City of Phoenix
PLANNING & DEVELOPMENT DEPARTMENT

Subject: P.H.O. APPLICATION NO. PHO-1-26--Z-29-23-7(8) – Notice of Pending Actions by the Planning Hearing Officer

APPLICATION NO: PHO-1-26--Z-29-23-7(8)

Request For: Stipulation Modification

preliminary site plan

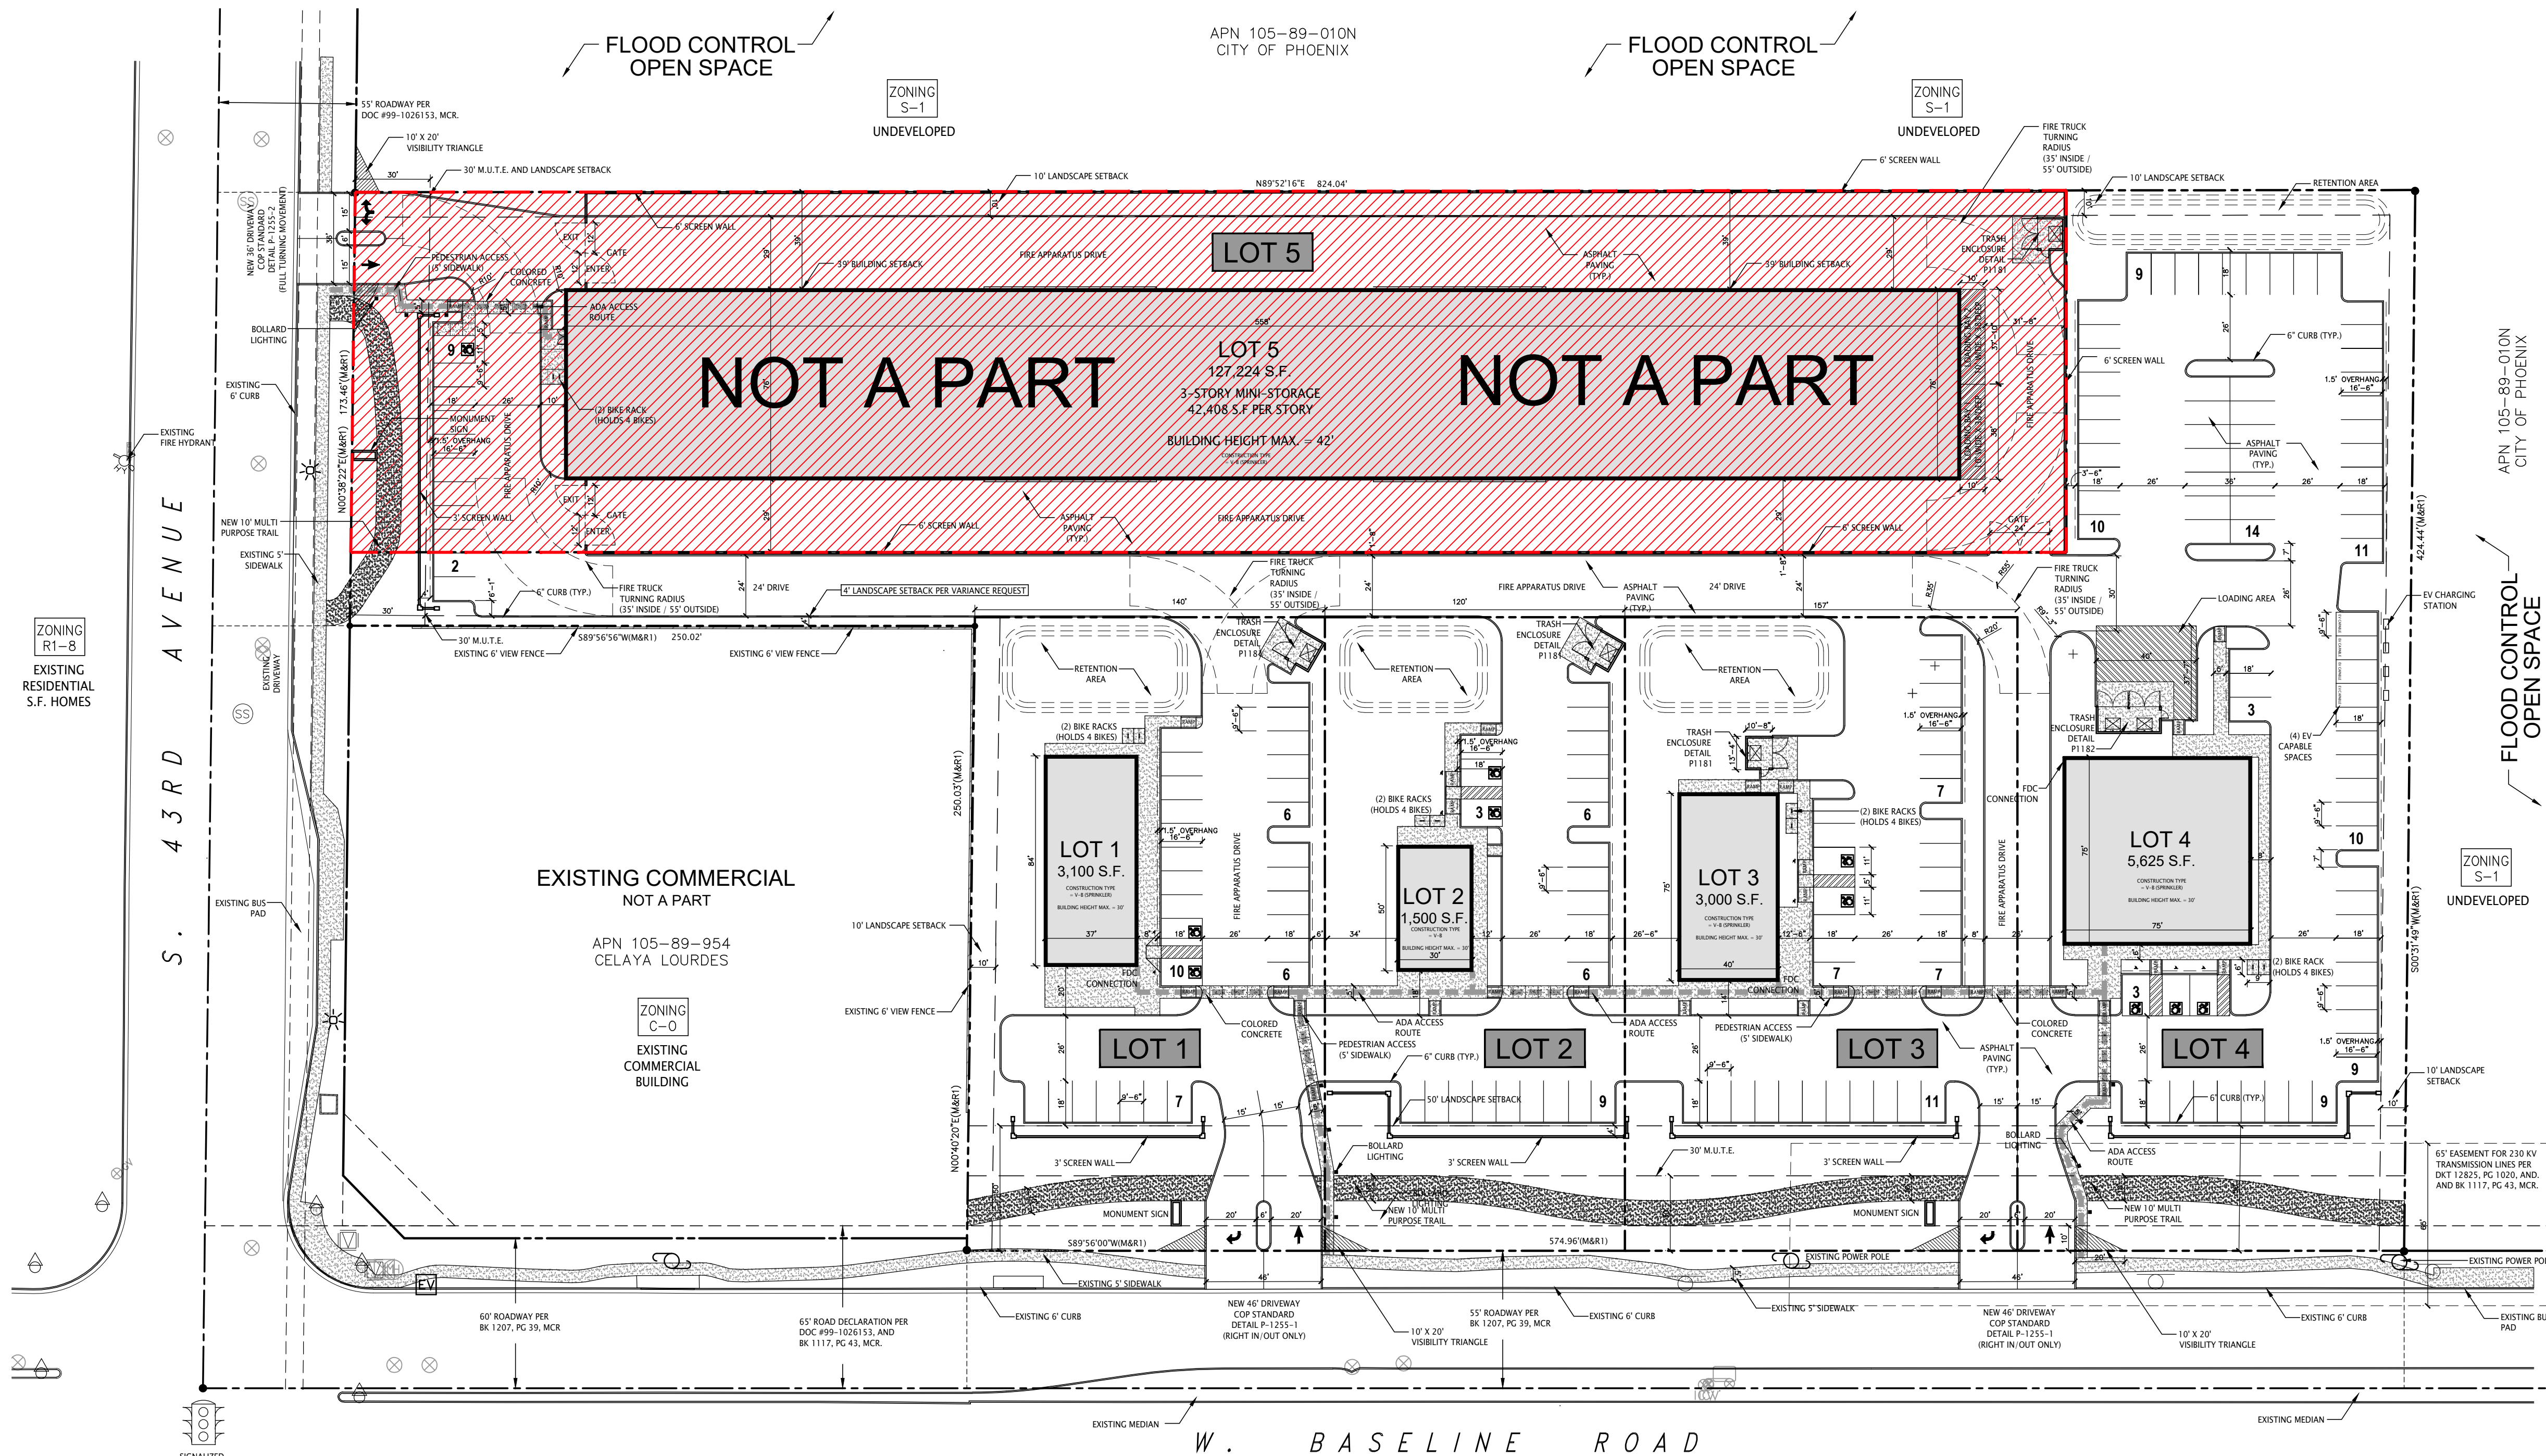
Lots 1, 2, 3, and 4, ~~and 6,~~ as depicted on the Site Plan date stamped ~~August 18, 2023~~ March 26, 2026

Stipulation 19: Conceptual site plan and elevations for Lot 4 ~~and Lot 6~~ shall be reviewed and approved by the Planning Hearing Officer (PHO) through the public hearing process for stipulation modification prior to preliminary site plan approval. This PHO review is a legislative review for conceptual building elevations only. Specific development standards and requirements may be determined by the PHO and the Planning and Development Department.

Response: As discussed above, the 2025 Rezoning Case eliminated Lots 5 and 6 on the site plan of the 2023 Rezoning Case. As such, the request is to modify the above stipulation to remove the reference to Lot 6 and update the date of the site plan.
